Access Compliance Report

Public Rights-of-Way

(Curb Ramps)

Intersection ID: 22490	Main Street: KENTDALE_CT	Cross Street: OXWYNN_LN	Location: NW
ADA ID: 35AF721DE7F8	Ramp Type: PerpDiag	Initial Pass/Fail: Pass	Overall Compliance: No
Severity Score: 7.5			
Codes/Mitigation Info/Possible Solution		Field Measurements/Component Compliance

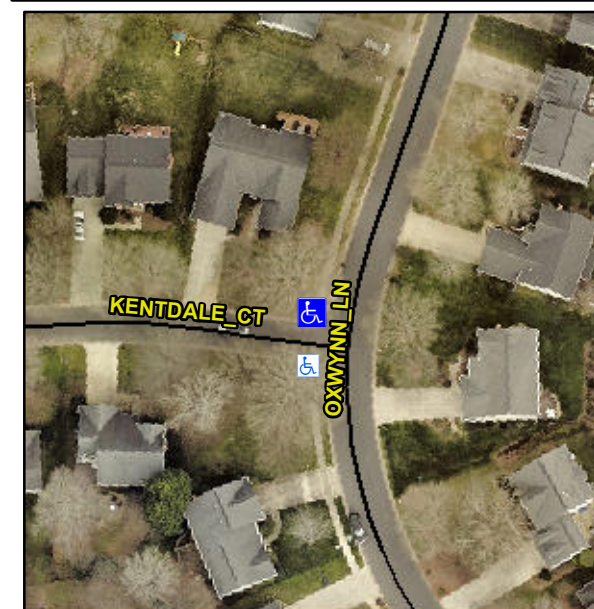
R304.2.1, R304.2.2-Perp, R304.3.2-Para, R305.1.4, R305.2, R304.5.4

Compliance	Description	Data	Compliance	Description	Data
N/A	Ramp Length (in)	46.0	Yes	Ramp Slope (%)	5.5
Yes	Ramp Width (in)	53.0	Yes	Ramp XSlope (%)	1.3
N/A	Flare Type LT	Sloped	N/A	Flare Type RT	N/A
N/A	Flare Slope LT (%)	4.5	Yes	Flare Slope RT (%)	2.6
N/A	Flare Traversable LT?	Yes	N/A	Flare Traversable RT?	Yes
Yes	Landing Length (in)	51.0	Yes	DWS Provided?	Yes
No	Landing Width (in)	41.5	Yes	DWS Contrast?	Yes
No	Landing Slope (%)	2.6	Yes	DWS Length (in)	25.5
Yes	Landing X Slope (%)	0.2	No	DWS Full Width?	No
N/A	Landing Curb? (Y/N)	No	No	DWS Offset (in)	4.0
N/A	Shared Landing?	No			
Yes	Gutter Ponding?	No	No	Gutter Slope (%)	7.3
Yes	Gutter Lip Ht (in)	0.0	Yes	Gutter X Slope (%)	1.3
N/A	Painted X Walk1?	No	N/A	Painted X Walk2?	No
	X Walk 1 Direction	To S		X Walk 2 Direction	To E
N/A	X Walk 1 Width (in)	N/A	N/A	X Walk 2 Width (in)	N/A
	X Walk 1 Slope (%)	4.1		X Walk 2 Slope (%)	0.2
	X Walk 1 X Slope (%)	0.9		X Walk 2 X Slope (%)	5.5

N/A	Ramp inside XWalk1?	N/A	N/A	Ramp inside XWalk2?	N/A
	Road Slope (%)	1.5	N/A	Clear Space?	Yes
	Road X Slope (%)	5.0	N/A	Clear Space to XWalk (in)	N/A
Yes	Any Obstructions?	No	Yes	Storm Grate/Utility Hazard?	No
	Obstruction Type			Storm Grate/Utility Type	
		N/A			N/A
			Yes	Surface Condition? (G/P)	Good

Remove & Replace Curb Ramp With Two New Directional Ramps or Equivalent. Remove & Replace Gutter.
